STATE OF CONNECTICUT SITING COUNCIL

PETITION NO. 1398

PETITIONER LSE PICTOR LLC'S RESPONSES TO SITING COUNCIL INTERROGATORIES **DATED APRIL 21, 2020**

**SITE DEVELOPMENT PLANS
PROPOSED 1.99 MW SOLAR ARRAY
PLATT HILL ROAD
WINCHESTER, CONNECTICUT
PREPARED FOR LODESTAR ENERGY**

PHASING PLAN - PHASE I
SHEET 9 OF 13
PROJECT # 032-2019
SCALE: 1" = 80'
DATE: 3/6/2020, Rev. 5/1/20

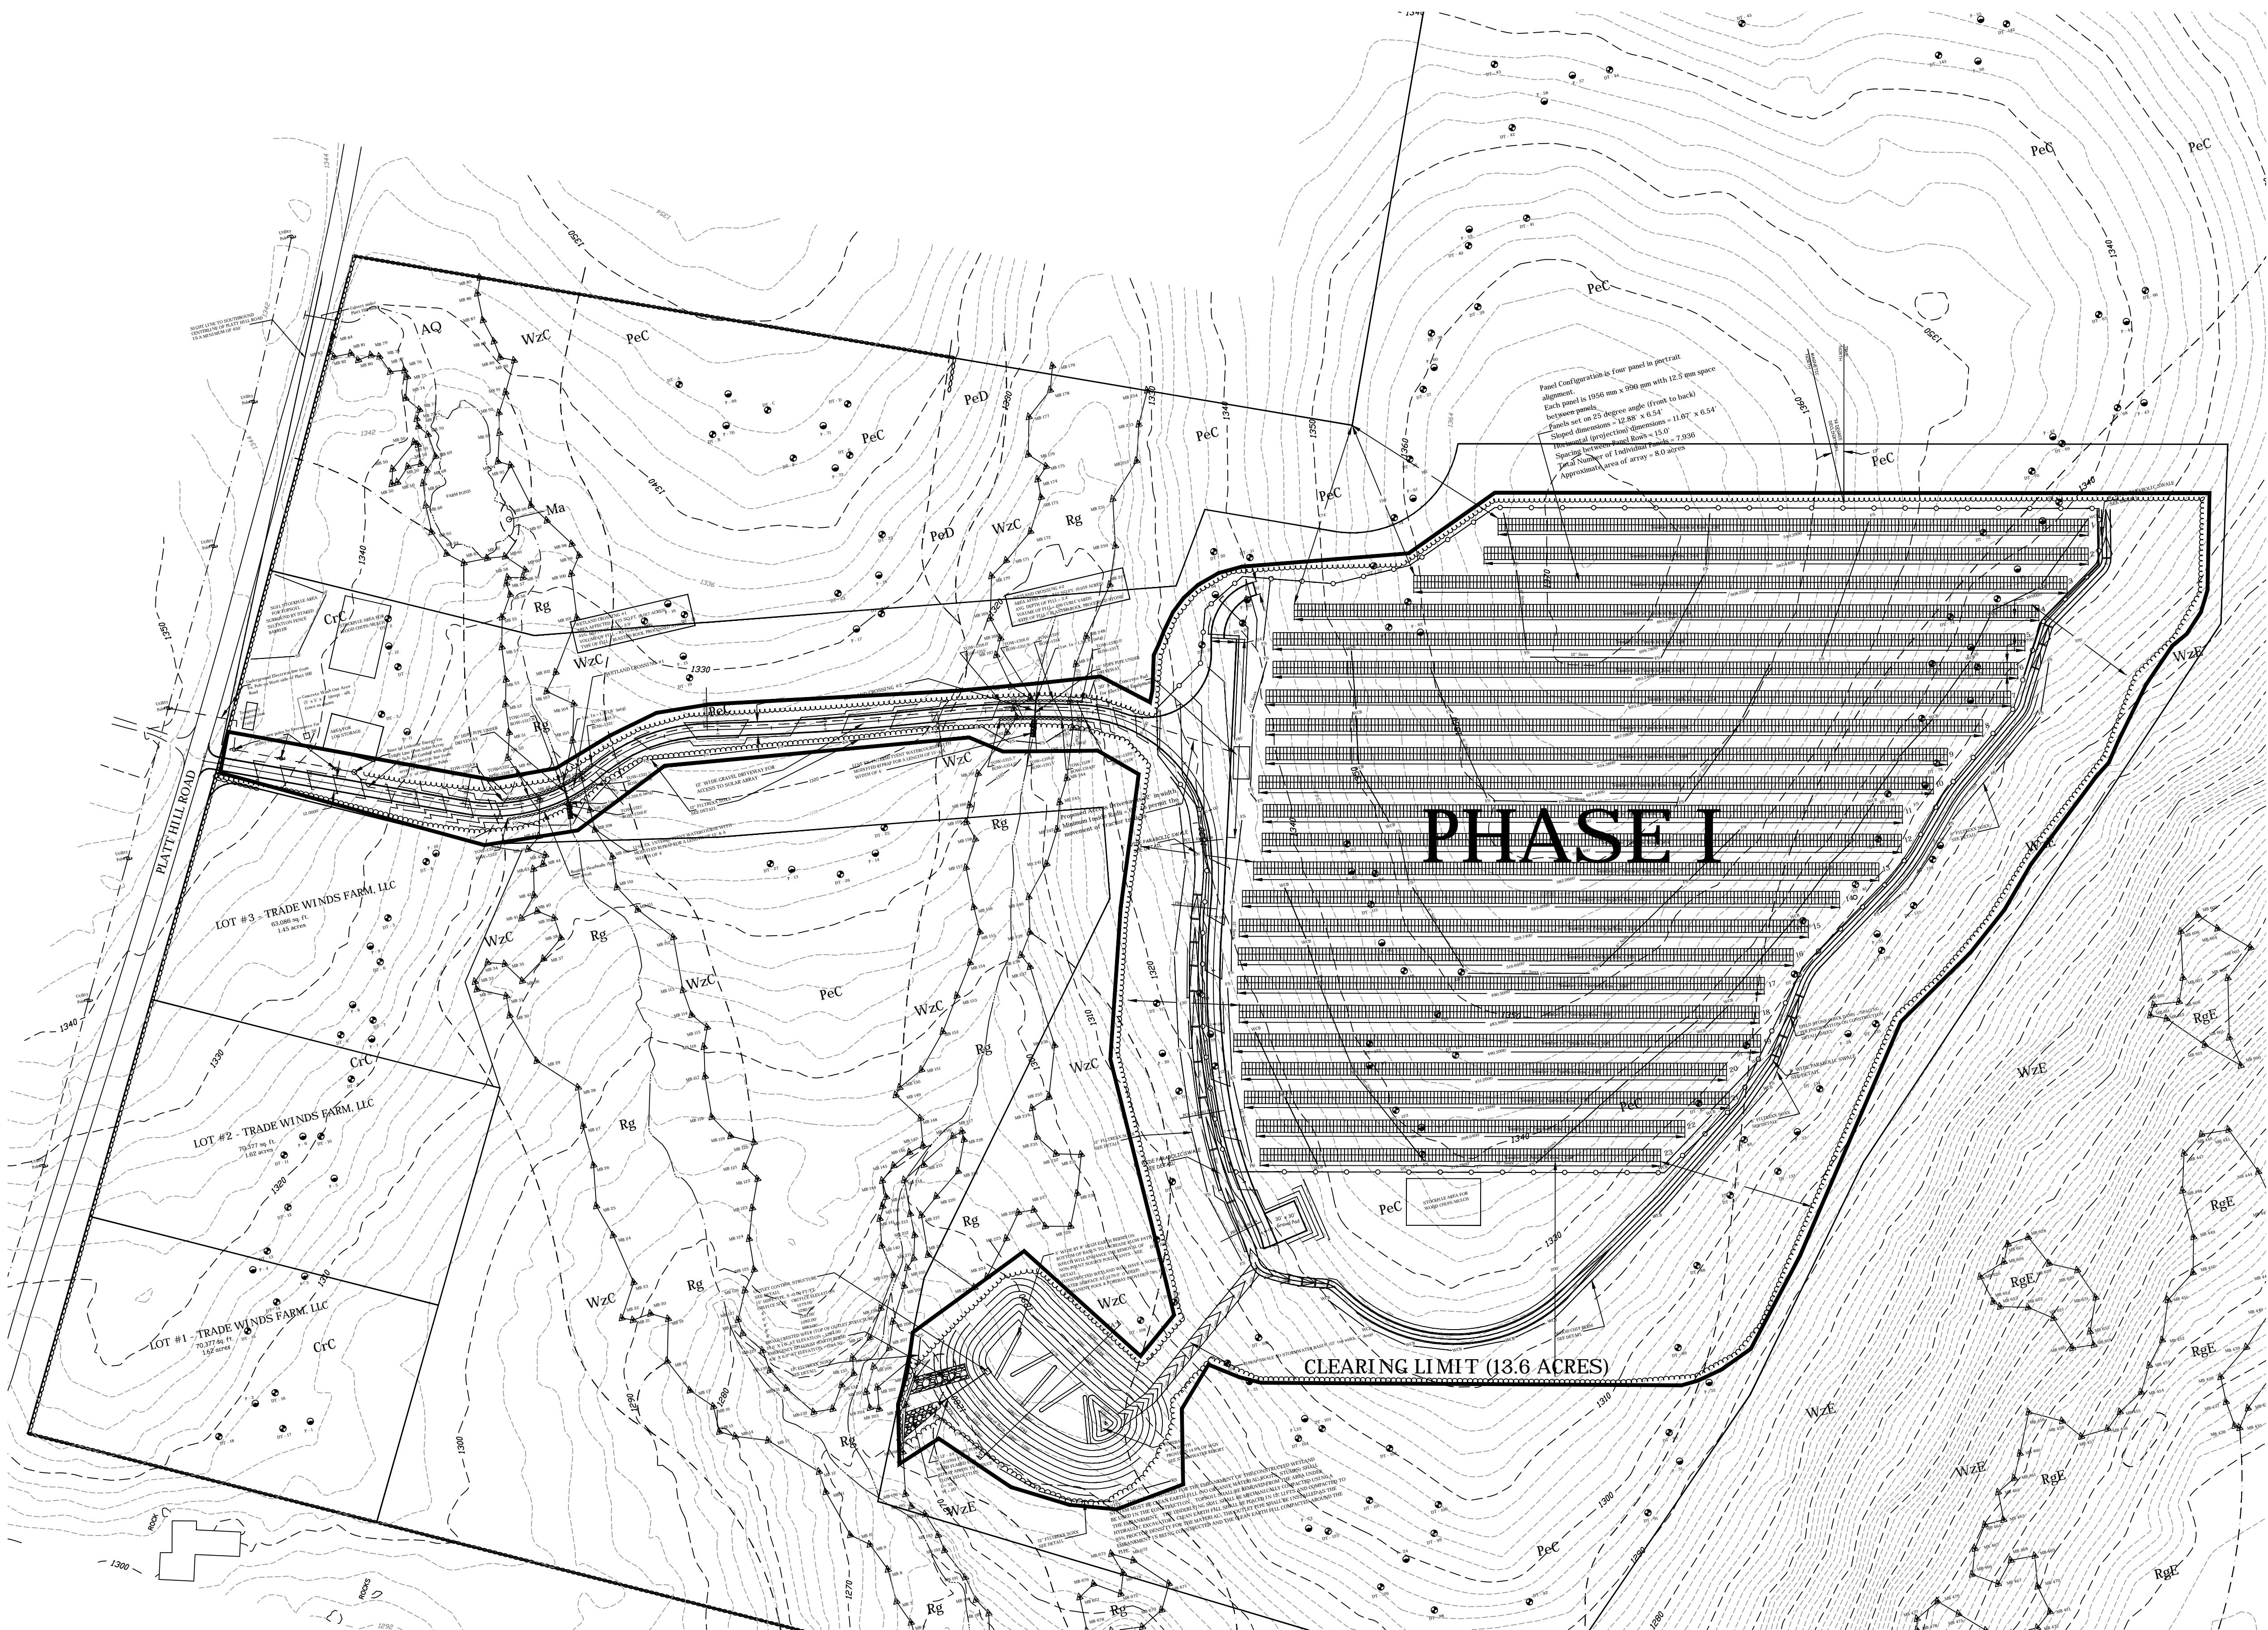
30. *For clarity, revise the Phasing Site Plans 9, 10, & 11 sheets to match the descriptions of each phase. Clearly show erosion controls per phase, site clearing limits, acreage of tree clearing, acreage of grubbing, stockpiles, and various seeding areas.*

31. *Site Plan Sheet 9, Phase I, provide plan detail of the temporary wetland crossings.*

33. *Site Plan Sheets 9 & 10 show limited clearing in the area of the large swale and associated wetland detention basin. How will tree cutting equipment and construction vehicles access this area using the limited cleared area shown? Provide revised plans that clearly show how access will be facilitated.*

Please see revised plans attached hereto as Exhibit A. Sheets 9, 10 and 11 are meant to show the limits of each phase of construction and provide an overview of the work being done in each phase. The construction sequence governs the work to be done in each phase. Sheets 3, 4, and 5 are the detailed plans which will be used by the contractor to perform the actual construction and all of the erosion control measures are clearing visible on sheets 3, 4, and 5 as they have a scale of 1" = 40', versus the scale of 1" = 80' for sheets 9, 10, and 11. Site clearing limits are shown on Sheet 9 already. For Phase I, no erosion controls are required by the CT DEP 2002 Guidelines as no soil disturbance will occur during this phase, only the cutting and removal of trees will occur. The phasing line on the plan has been moved so the erosion controls are visible on sheet 9, 10, and 11. Acreage of tree clearing has already been provided on sheet 9 and is 13.6 acres. A stockpile is already shown on the plan for material excavation for the construction of the driveway. Stockpiles are not required in the area of the solar array as we are not removing soil for the area of the solar array. Excavation material for the construction wetland will be used to construct the berm of the constructed wetland.

Please see revised plans attached hereto as Exhibit A, which show the proposed temporary wetland crossing utilizing logs which are placed parallel to the stream will be used to provide access for the timber clearing.

Please see revised plans attached hereto as Exhibit A. The clearing limited has been slightly expanded to forty feet (40') to accommodate excavation equipment.

PHASING PLAN - PHASE II
SHEET 10 OF 13
PROJECT # 032-2019
SCALE: 1" = 80'
DATE: 3/6/2020, Rev. 5/1/20

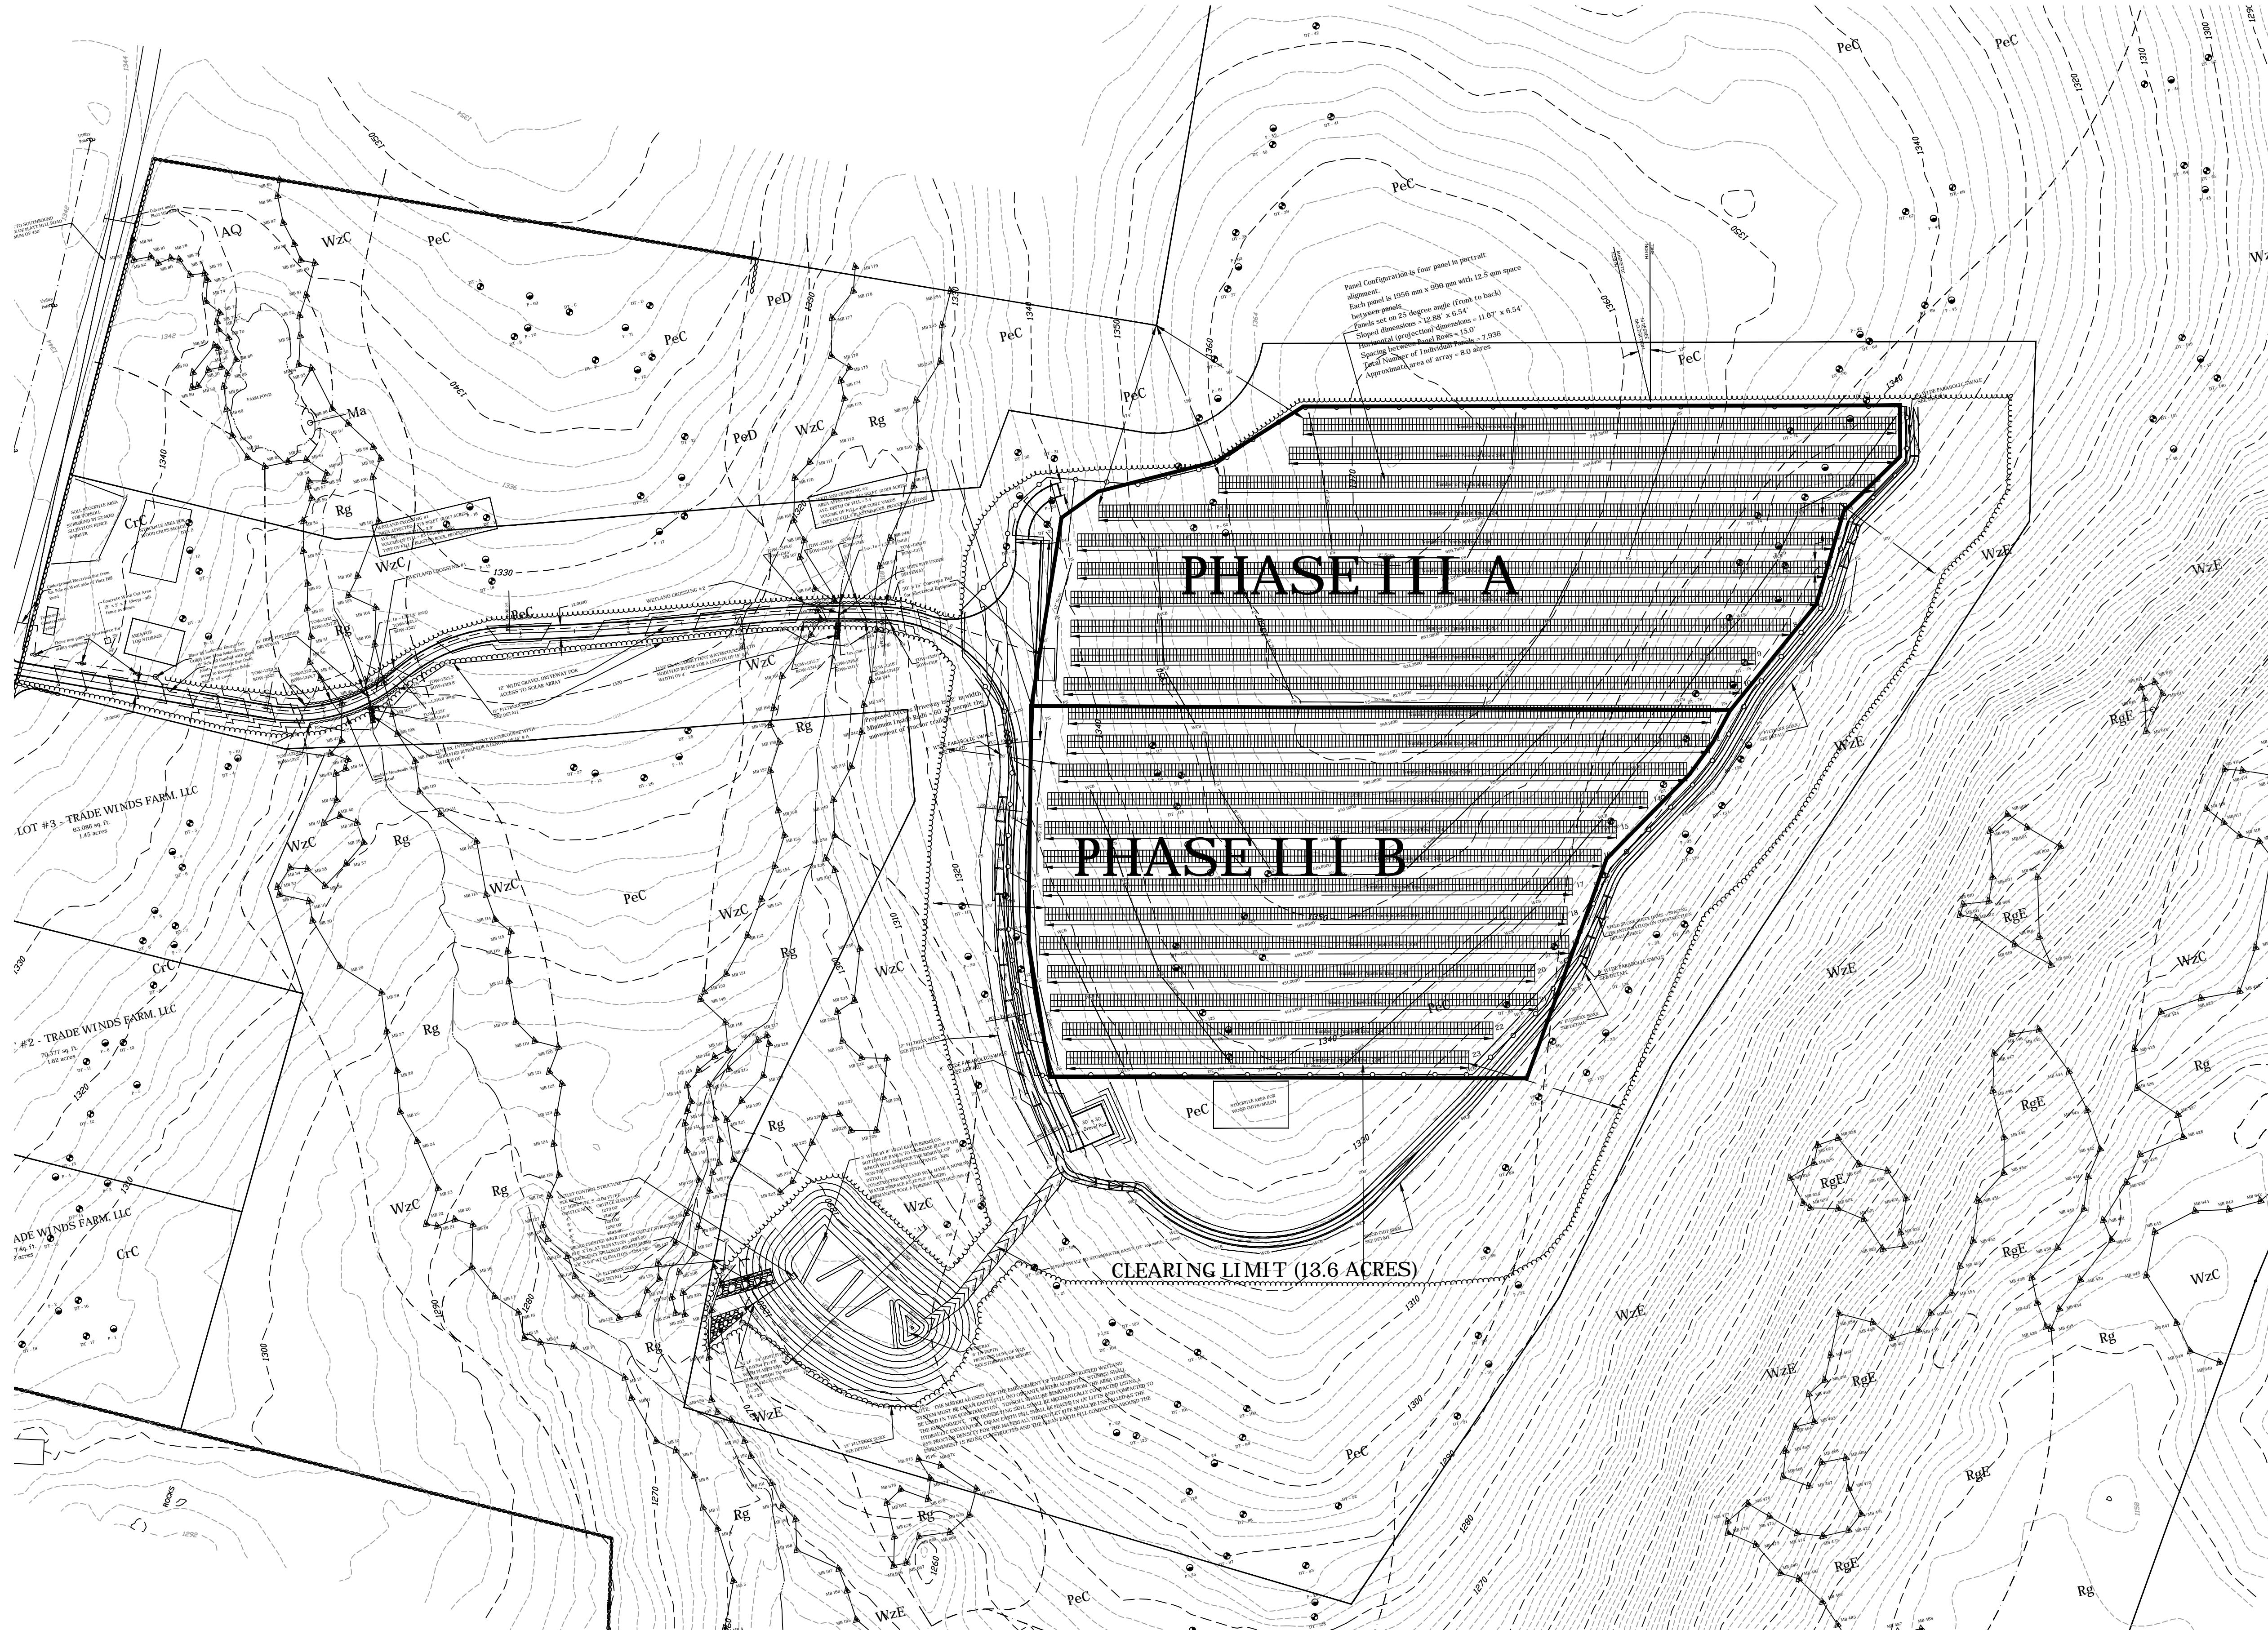
32. *Site Plan Sheet 10, Phase II clarify the following:*

- a) *Will dewatering procedures be necessary to construct the wetland detention basin? Provide detail.***
- b) *What material will be used to fill holes/depressions resulting from stump removal?***

Please see revised plans attached hereto as Exhibit A. Petitioner does not anticipate that dewatering will be needed to construct the wetlands basis but, in the event it is needed, the detail has been included in Exhibit A. Native soil will be used to fill in any holes remaining following stump removal. Phase IIIA would commence two (2) weeks after the completion of Phase II as additional erosion control measures consisting of Filtrexx Soxx and Wood Chip Berms will be utilized to maintain non-erosive velocities of any runoff.
